RE: Ceja Vista  
10001 Ceja Vista Road SW  
Zone: R2  
Submittal: TCL for Final C.O. of Phase 1

This certification is submitted in support of a request for Final Certificate of Occupancy for Phase I of the project as shown on the attached TCL1 plan.

SITE PLAN  
FOR BUILDING  
PERMIT

SDP1.1

NORTH  
A1 SITE PLAN  
1" = 50'-0"

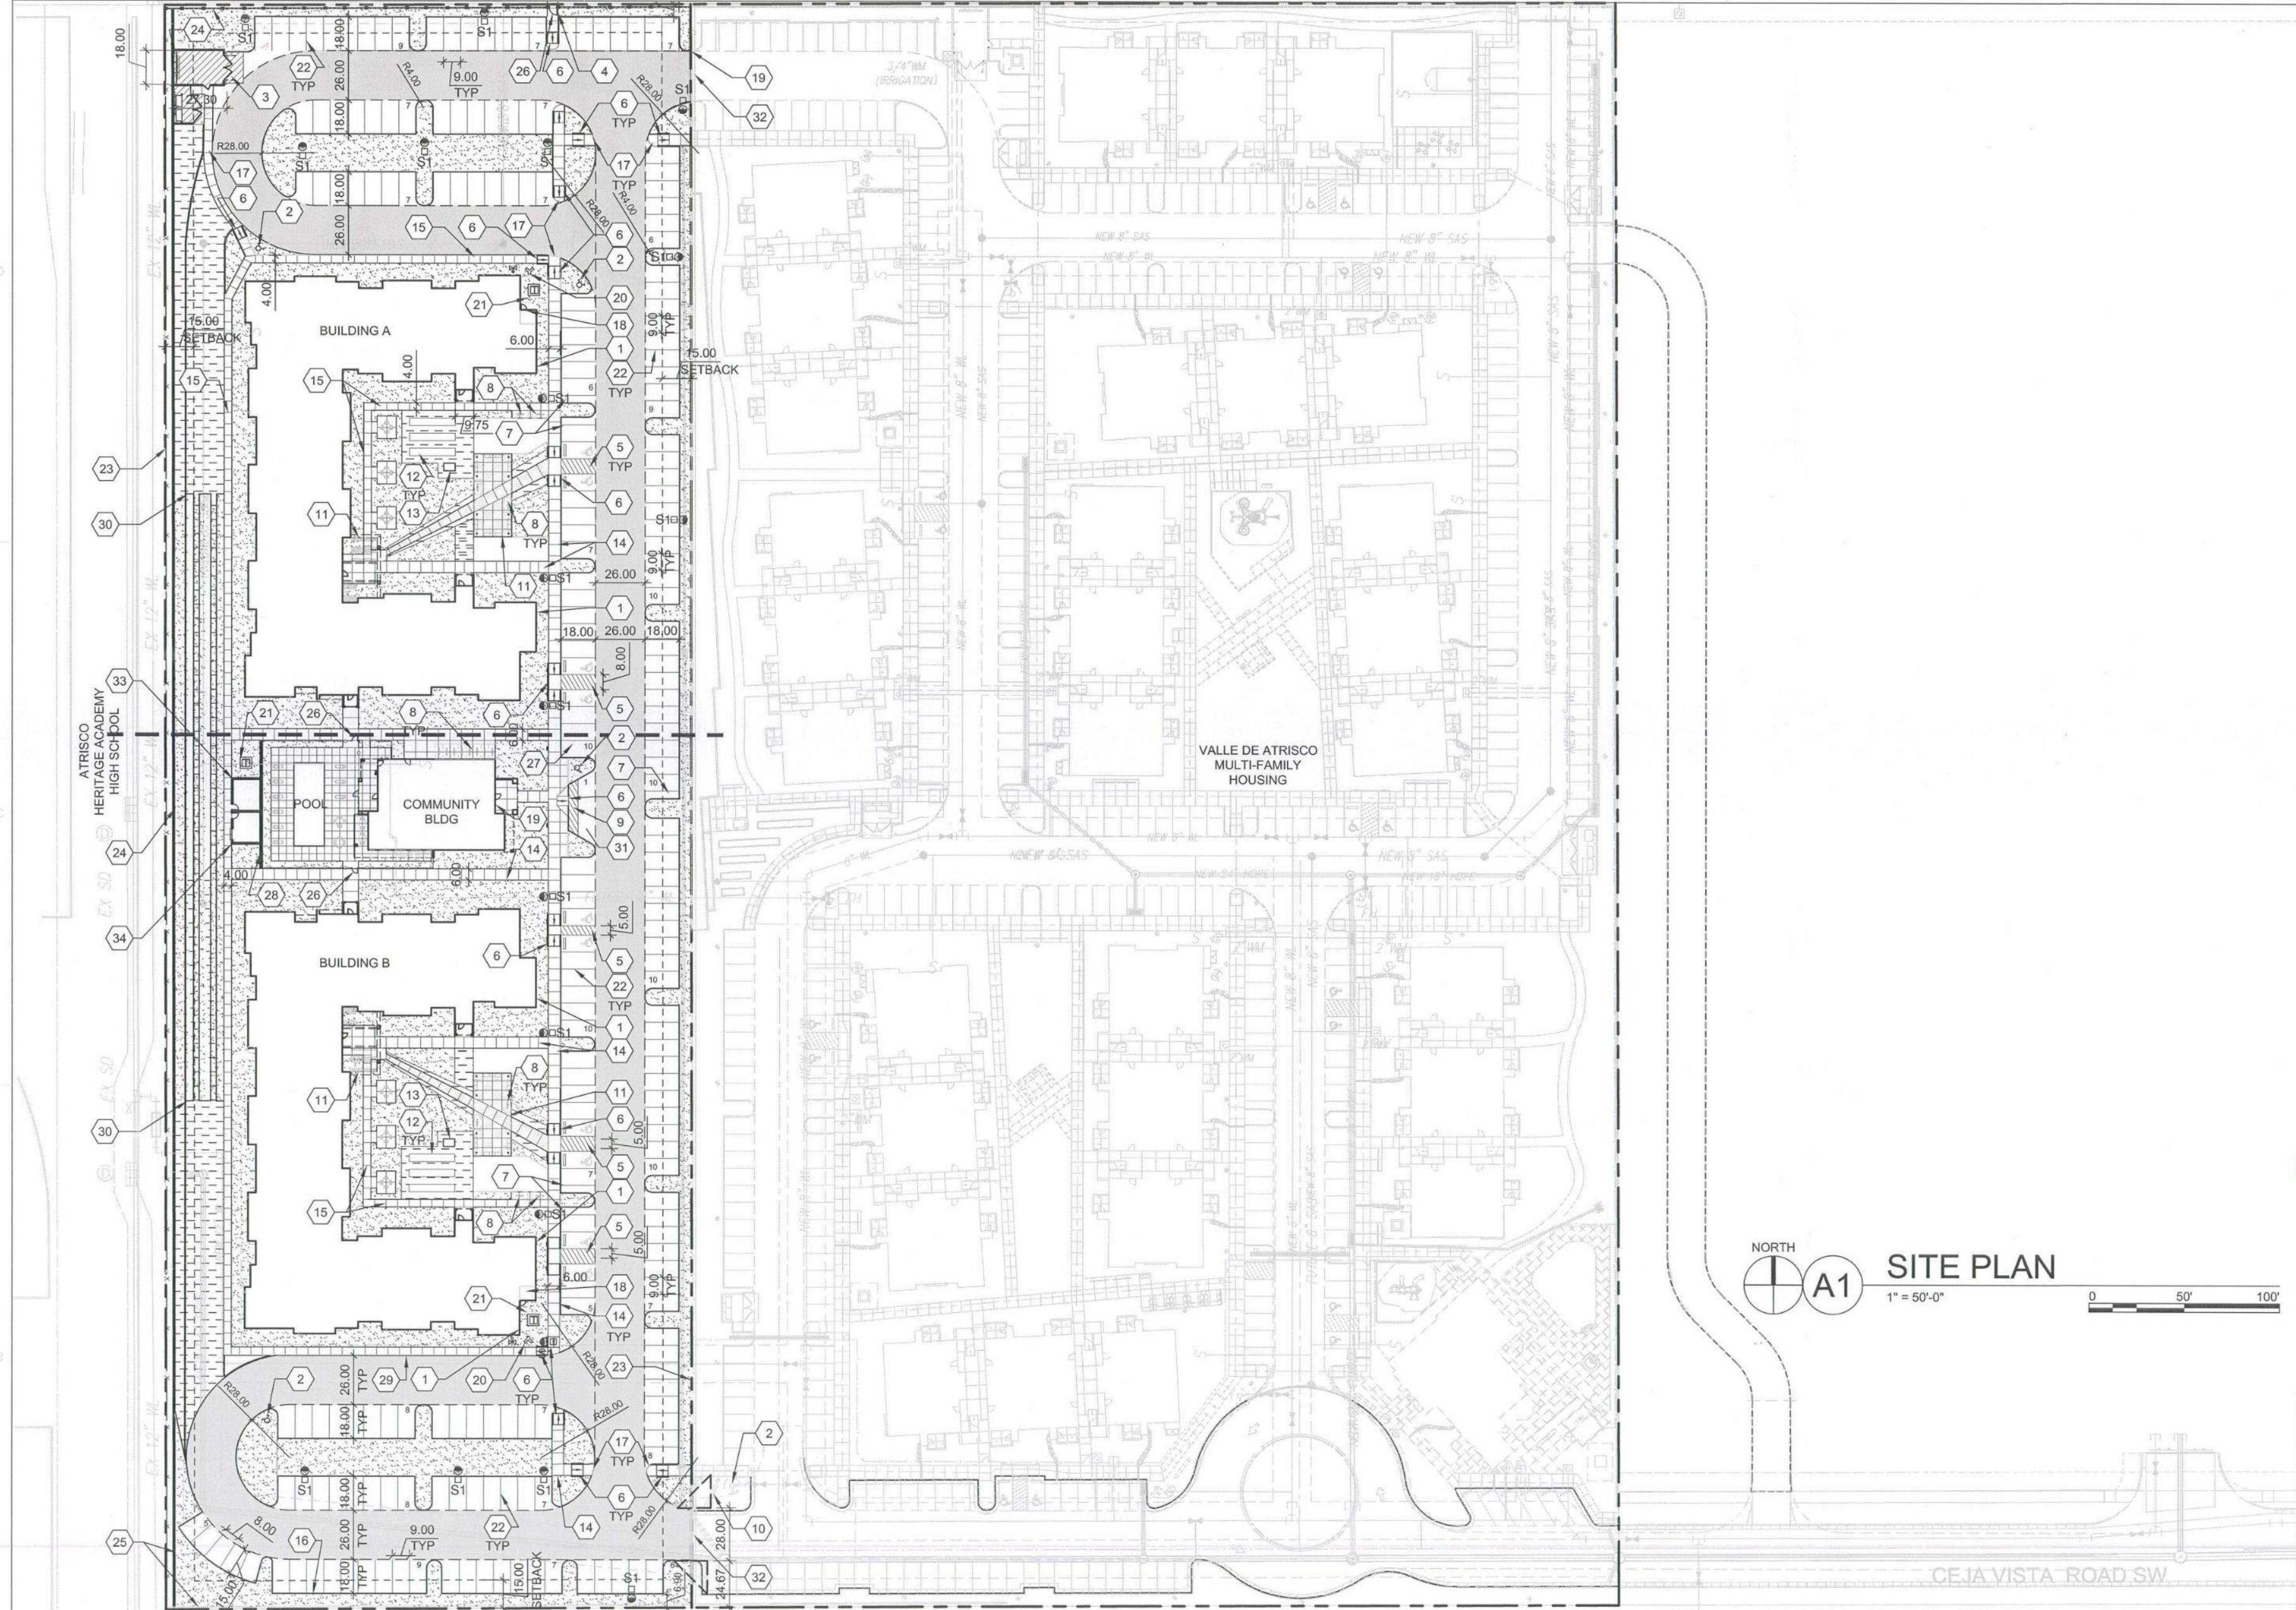
- Fire access gate was omitted during construction. Knox Box no longer required at this location.
- City Comment Response - Pedestrian gate has been installed as of 5/22/2023 and walkway connection to Dennis Chaves Blvd. have been installed as of 5/22/2023:

- ADA access route was revised and red lined on plan.
- 2 sidewalk ramps were omitted per changes in the ADA access route.
- Block wall at Trash Compactor is in progress. It is currently at 6'-8" and the final height is 9'-4".
- Gates at Trash Compactor and Enclosure have been installed as of 5/22/2023.

- Trash Enclosure was revised to accommodate 5 trash bins from 2 bins. Changes have been approved by Solid Waste and COA.
- Pool and outdoor showers were omitted during construction. Artificial turf and a shade structure were installed in place of the pool.
- Fence around opens space has been revised and installation is in progress as of 5/22/2023.
- Building mounted lights are not yet installed.
- City Comment Response - Van Pool Parking signage has been installed as of 5/23/2023.

- Speed table and stamped concrete were omitted during construction. Speed bumps will be installed at a later date.
- City Comment Response - Pathway striping at speed table was omitted during construction with omission of speed table.
- City Comment Response - Van accessible aisles have been revised to be 8 feet wide as of 5/23/2023.

- City comment Response – Sidewalk in front of Trash Enclosures has been revised to be 5 feet wide per plans.

TRASH COMPACTOR  
ENCLOSURE WALLS ARE  
INCOMPLETE. BLOCK TO  
COMPLETE IS ON ORDER

GATES ARE ON ORDER

SIDEWALK IN FRONT OF  
TRASH ENCLOSURE  
HAS BEEN WIDENED TO  
5 FEET AS OF 5/22/23TRASH ENCLOSURE WAS  
REVISED TO ACCOMMODATE  
5 BINS FROM 2 BINS.OUTDOOR SHOWERS  
OMITTED BECAUSE  
POOL WAS OMITTED.FENCE BOUNDARY  
REVISED, NOT YET  
INSTALLEDPOOL OMITTED; ARTIFICIAL  
TRUF WITH SHADE COVER  
INSTALLED IN ITS PLACELIGHTING NOT YET  
INSTALLEDPHASE 1  
PHASE 2FIRE ACCESS GATE WAS  
OMITTED.  
ENTRY GATE  
OMITTED.  
PEDESTRIAN GATE  
OMITTED  
RELOCATED ACCESSIBLE  
SITE ACCESSVAN ACCESS AISLES  
HAVE BEEN REVISED  
TO BE 8 FEET WIDE AS  
OF 5/22/23STRIPING WAS  
OMITTED WITH  
OMISSION OF SPEED  
TABLE RAMPVANPOOL PARKING  
SIGNAGE HAS BEEN  
INSTALLED AS OF  
5/23/23SPEED TABLE RAMP  
WAS OMITTED.  
SPEED BUMPS WILL  
BE INSTALLED AT A  
LATER DATE.STRIPING WAS  
OMITTED WITH  
OMISSION OF SPEED  
TABLE RAMP
